BID BULLETIN

Project Name: **Repair and Renovation of Research Extension Services and External Linkages Building (RESEL) (ABC: Php. 1,799,039.62)**

EXISTING WALL MOUNTED WMSU LOGO

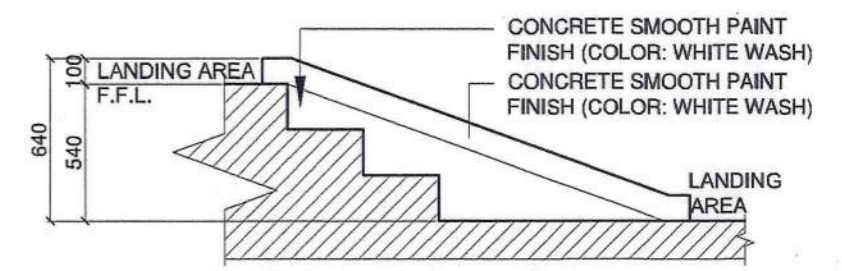
1. Sheet# 7/A07 of the drawing plans is modified to show the inclusion of the Specifications of the Existing Wall Mounted WMSU Logo. Please see attached amended sheet #7/A07 the drawing plans.
2. Sheet# 11/P02 of the drawing plans is also modified to add item #17 **2" Diameter PVC Pipe S-1000 Branch Vent Pipe (The Height of the Branch Vent Pipe shall be 6" minimum above the highest plumbing fixture)** in the General Notes and in the Sanitary Isometric Diagram, and:
3. In Section III. Bid Data Sheet ITB Clause 10.4 List of Key personnel, the **Site Engineer** must be a **Licensed Civil Engineer** with General and Relevant Work Experience of 3 years.

- CONCRETE SMOOTH PAINT FINISH SOLVENT BASE (COLOR: WHITE - TO ARCHITECT'S APPROVAL)
- CONCRETE SMOOTH PAINT FINISH SOLVENT BASE (COLOR: CRIMSON RED)
